LAW OFFICE OF MARC CHYTILO, APC

RE: Community Assembly Parking Lot Lighting, 478 Cambridge Drive, Goleta, CA
Case Nos. 25-0033-DRB, 24-0052-ZC

Figure (8). Manufacturer’s isofootcandle plots for BLC4 and T5W luminaires

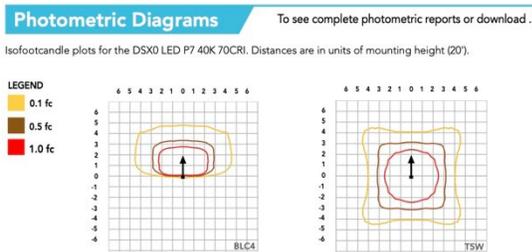
LED light distribution patterns are displayed through isofootcandle plots, with concentric rings delineating bands or groupings of light intensity. *An isofootcandle plot describes the intensity of direct light on the surface under a fixture and not the incidental light produced by a luminaire such as backlight, uplight, and glare.* The manufacturer’s spec sheets for the Project’s luminaires are shown in Figure 8 and 9 below:

The photometric study does not depict the actual light distribution of the double light heads for the T5W lights and only shows the isofootcandle plot of one luminaire, not two. The Project’s double light heads will carry one luminaire per side, two per pole for a total of four lights of 4,878 lumens – at 184% of ambient streetlight each - on the south side of the property. The applicant’s choice of T5W luminaires places the footprint of one almost directly over the other, effectively doubling the intensity and brightness of not only the direct light but also its glare.

Figure (10). Applicant's lighting plan.

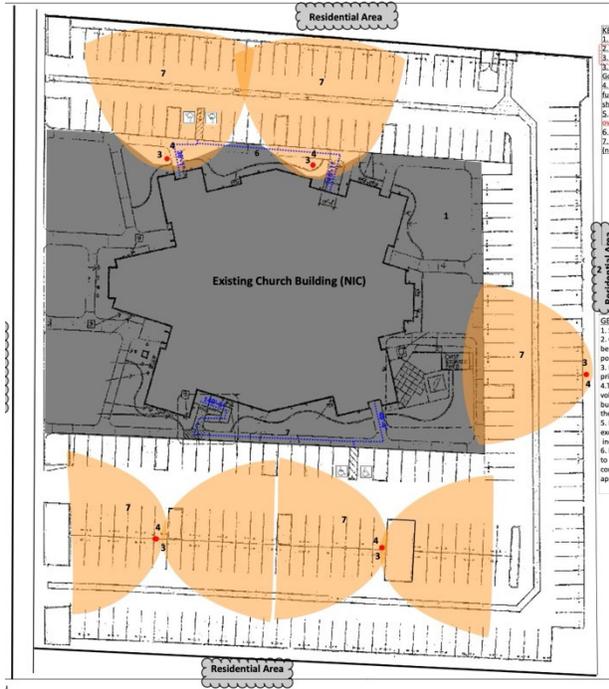
The applicant’s photometric study is inaccurate and misleading. It notes on the plan itself that it is ‘not to scale.’ Having an accurately scaled plan is critical to be able to evaluate the potential impact of the Project’s lights. Further, instead of using the whole isofootcandle plot, which would depict the area of furthest extent of its 0.1 foot-candle ring, the photometric study depicted only one ring of light density – 1.0 fc (red) for the BLC4 and 0.5 fc (brown) for the T5W luminaires (Figure 8). This is borne out by the isofootcandle plot numbers depicted on the study, as there are areas of 0.5, 0.4, 0.3, and 0.2 isfc outside the applicant’s depicted lines.

Further, the lighting plan provided in the plans do not match the isofootcandle plots using the manufacturer’s specifications. The extent, direction, and spread of the light are vastly different.

Inaccurate Photometric Plan

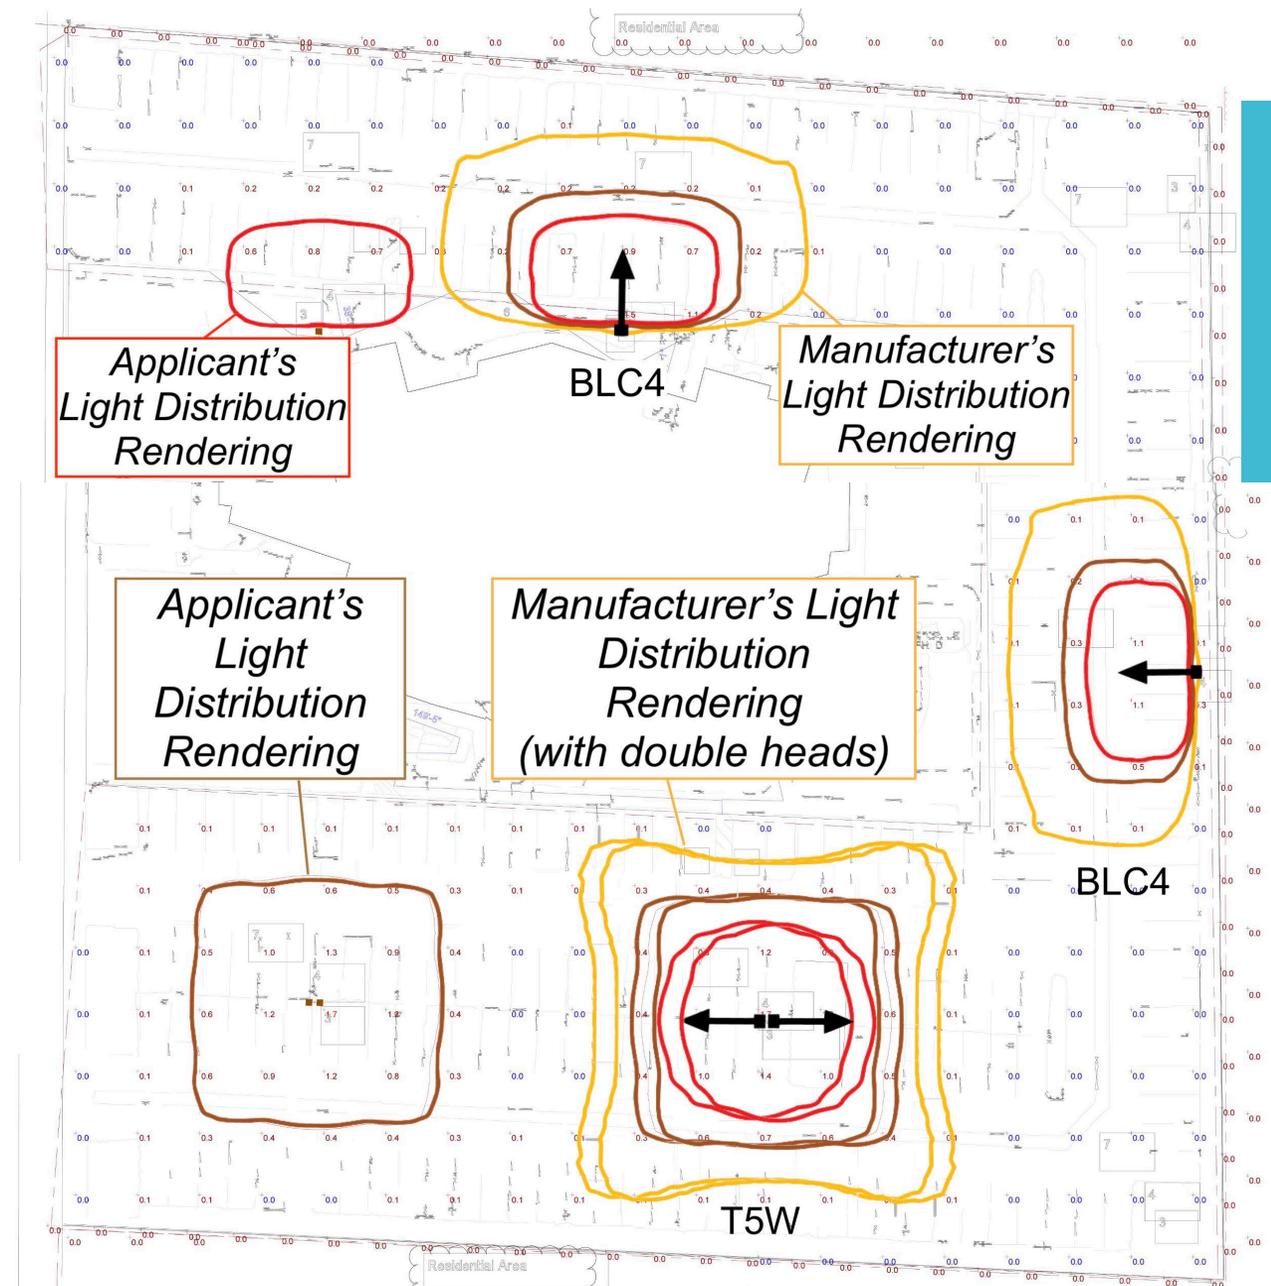
*Applicant's photometric plan minimizes the appearance of the fixtures' light distribution by omitting inclusion of all three isofootcandle outlines of distribution and intensity plots.

*Isofootcandle light distribution plot does not match the light distribution schematic provided in the plans.

Inadequate Shielding of Light Fixture

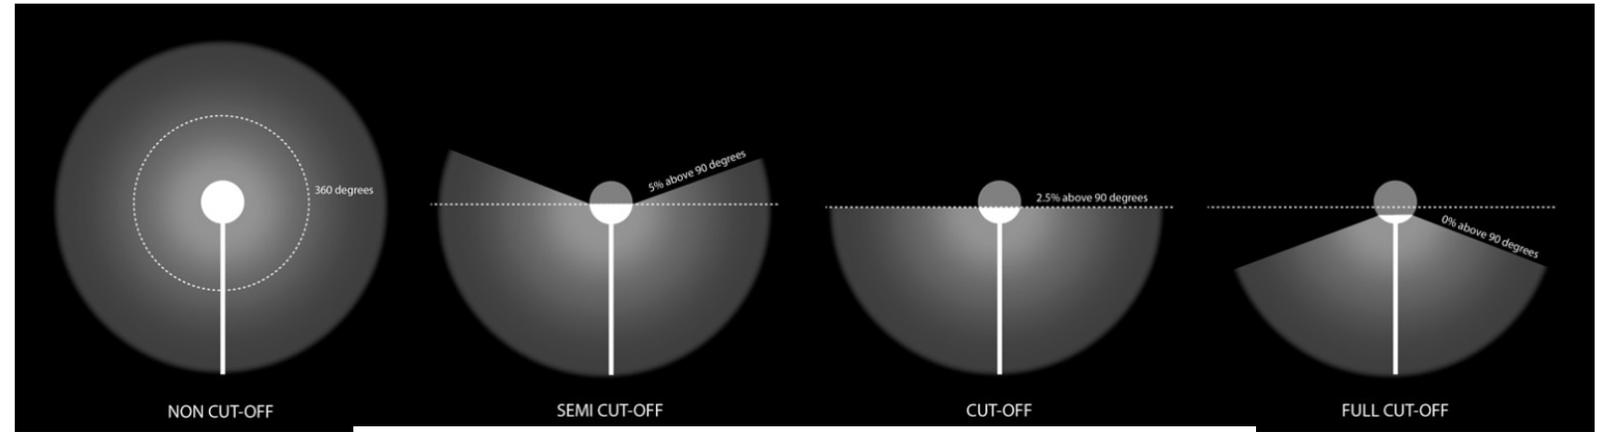
Not full cutoff, only partial cutoff

Lighting Schedule L contradicts the Commission's direction requiring full cutoff, motion sensors and confuses the issue of glare shrouding
